FALCON MEADOWS AT BENT GRASS DRAINAGE CHANNEL

CONSTRUCTION DRAWINGS (PLAN & PROFILE)

CDR-21-014

PROJECT COST RESPONSIBILITY EXHIBIT

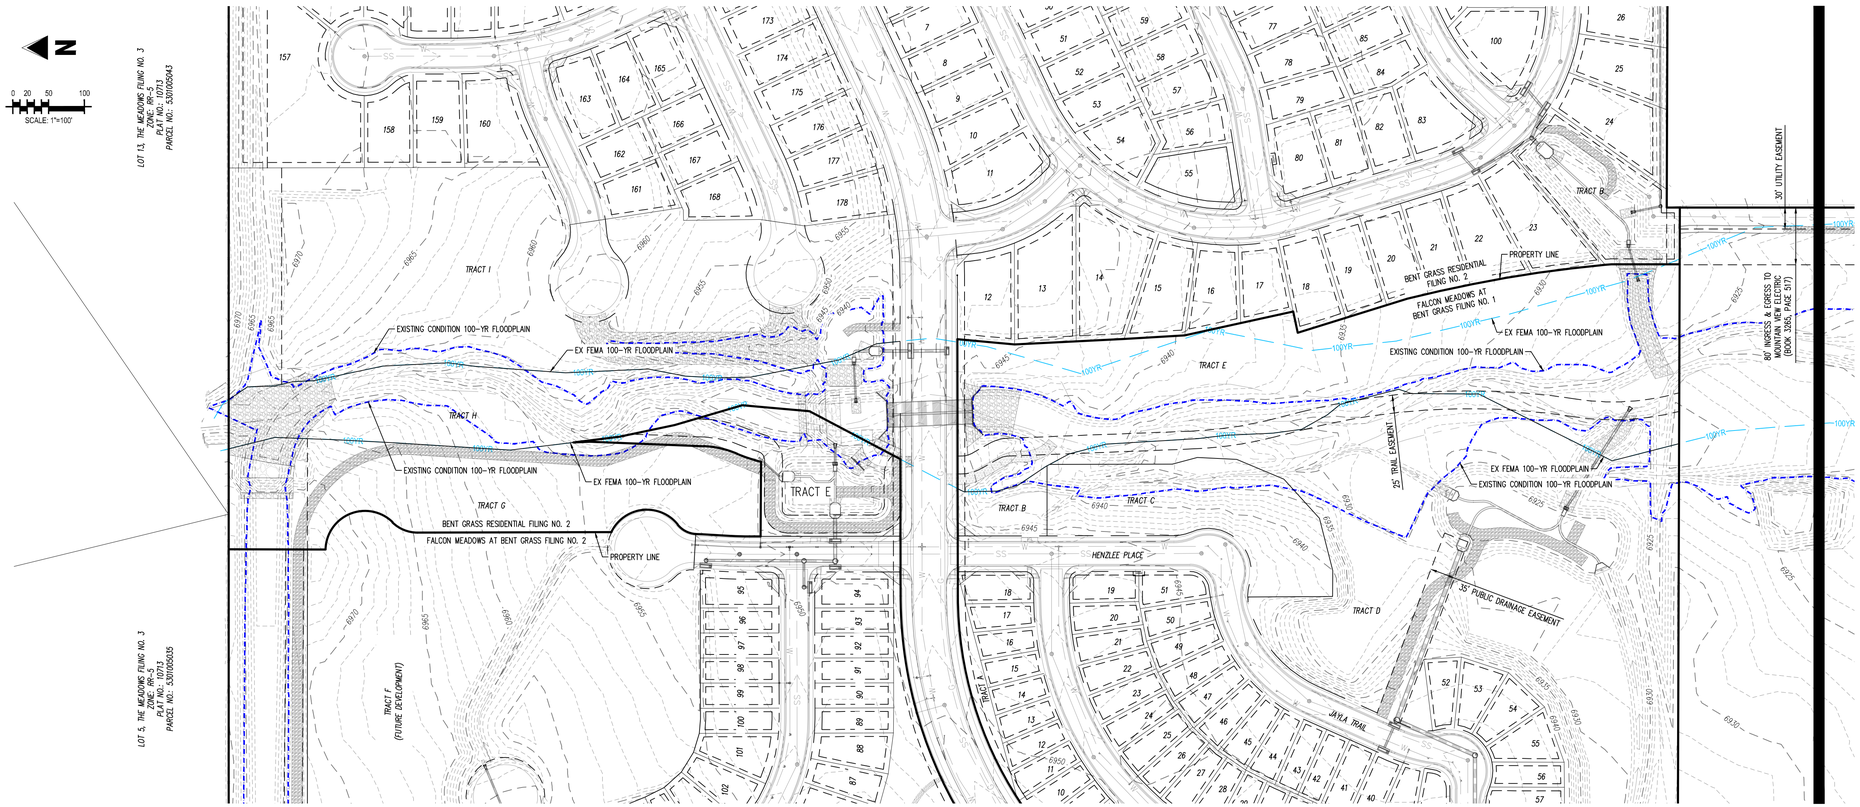
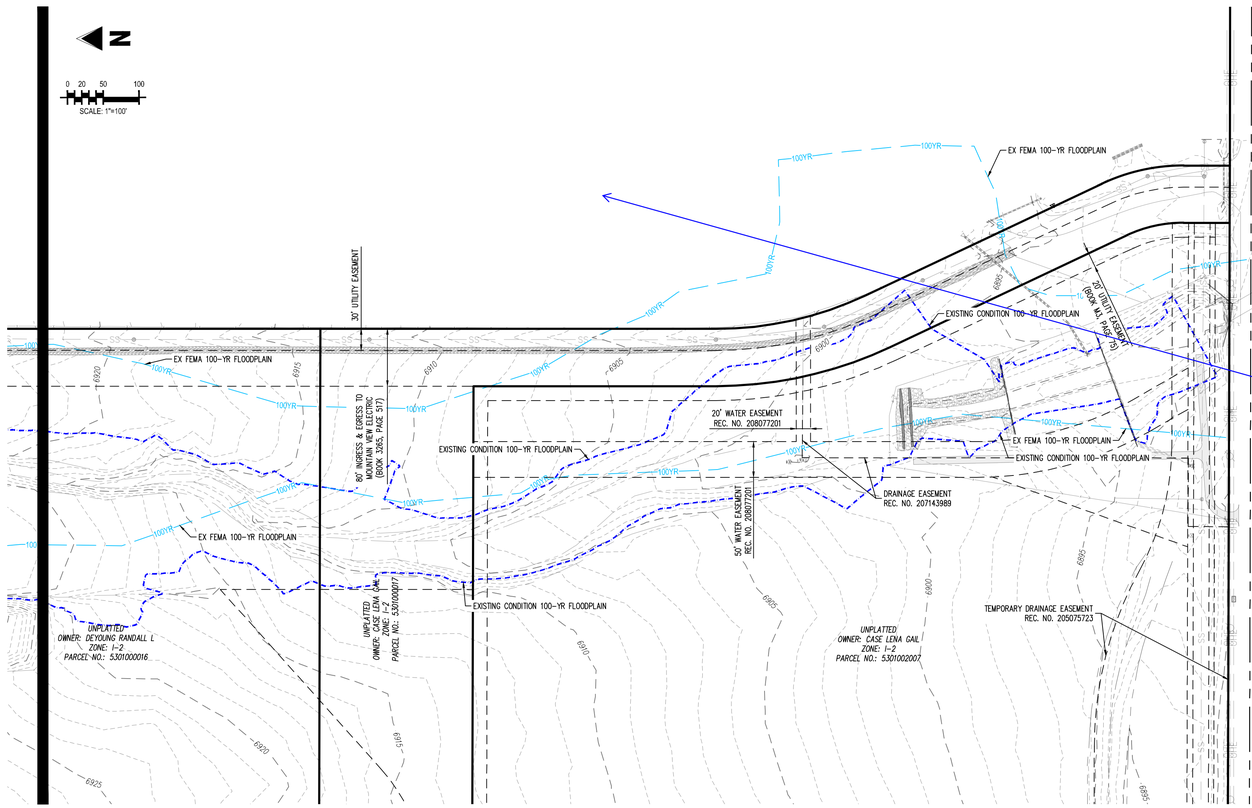
A couple labels were lost - MVEA and Woodmen Road

TYPICAL CHANNEL SECTION
NOT TO SCALE

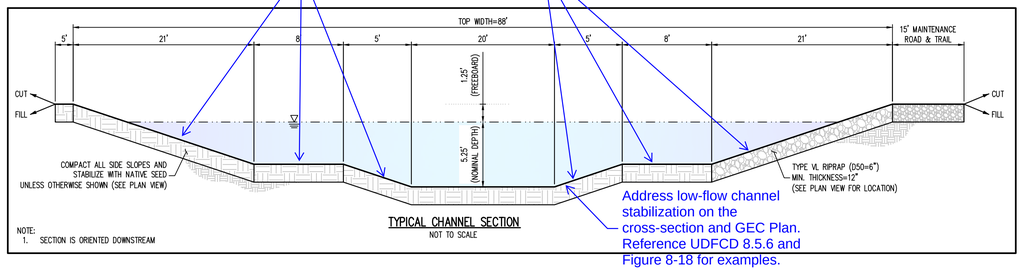
Label side slopes (4:1?) and bench grades

Address low-flow channel stabilization on the cross-section and GEC Plan. Reference UDFCD 8.5.6 and Figure 8-18 for examples.

PLAN VIEW – SOUTH CHANNEL (STA: 9+85.00 – 19+25.00)

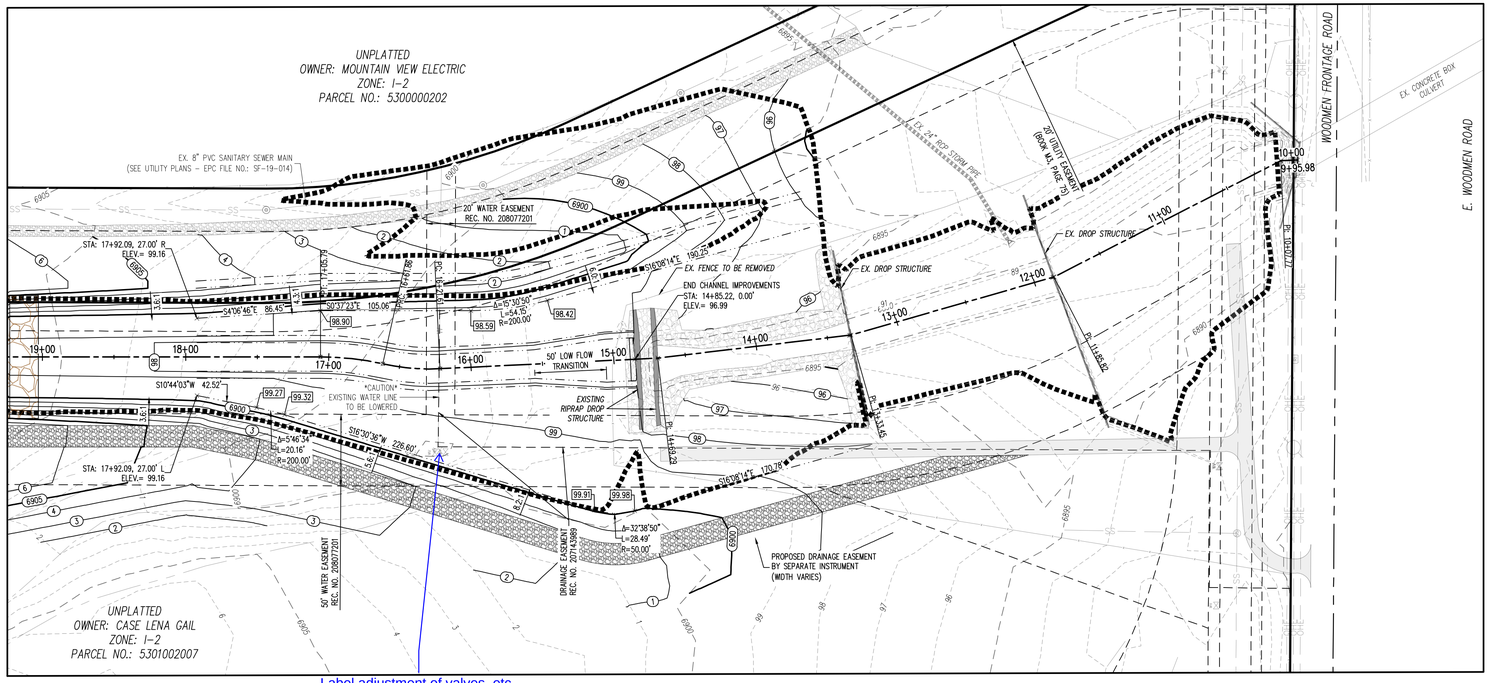
Label adjustment of valves, etc.

Provide cross-section and details of water line lowering with district signature block.

NORTH CHANNEL SECTIONS

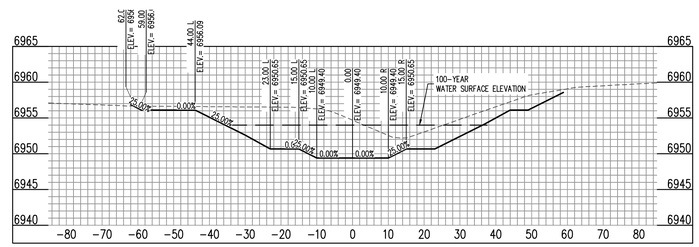
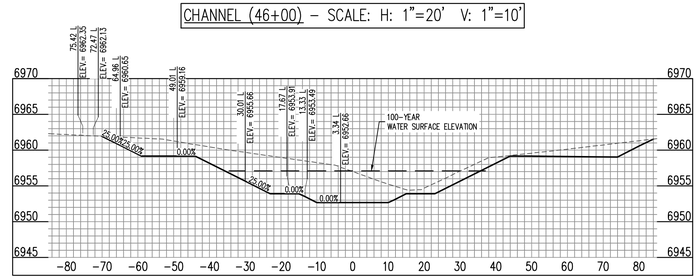
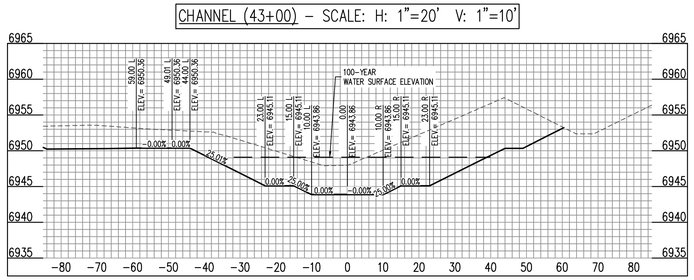
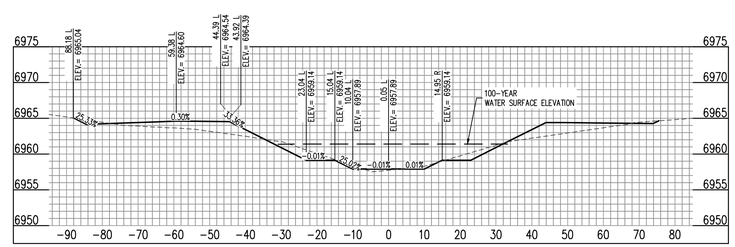
Label all hinge points

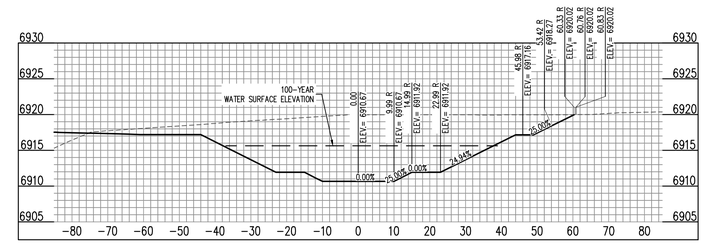
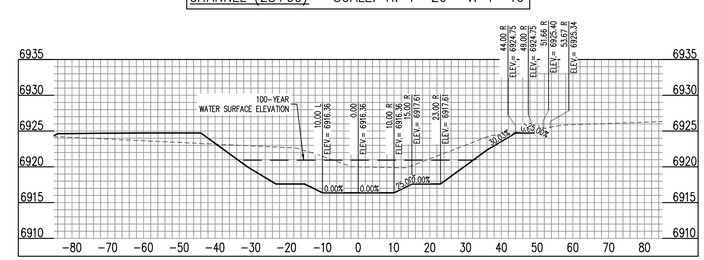
Label all hinge points

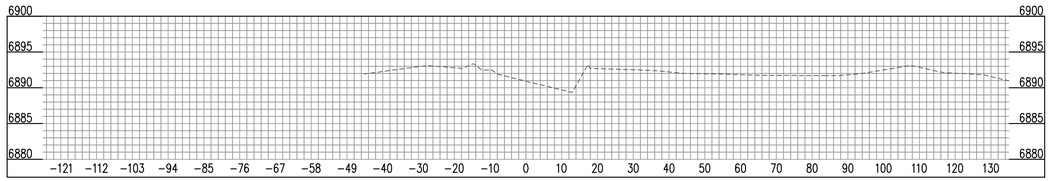
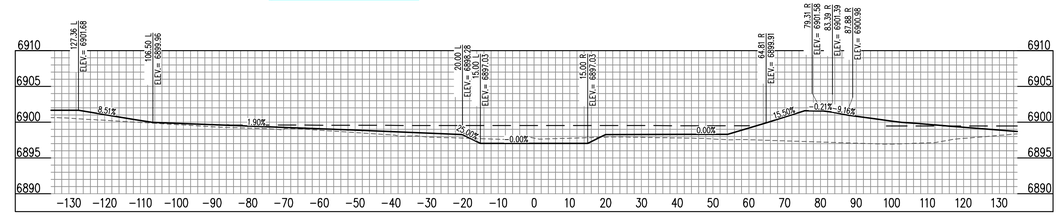
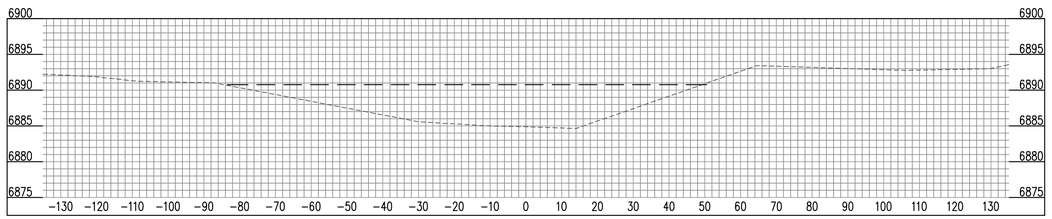
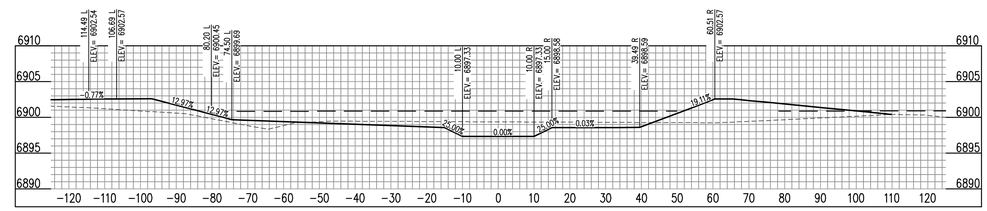
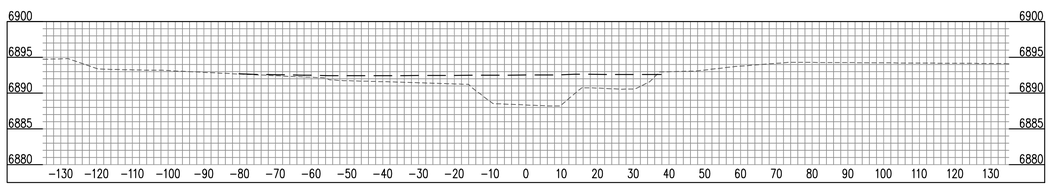
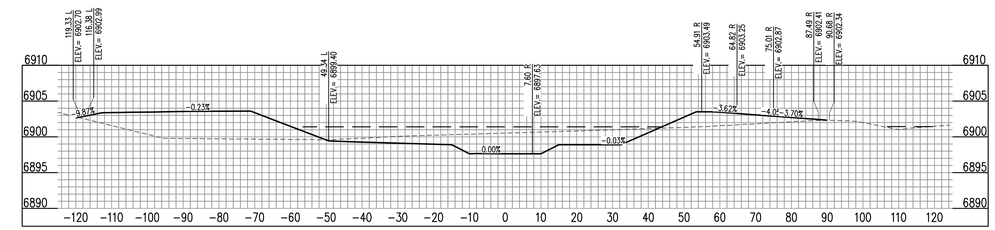
Label all hinge points
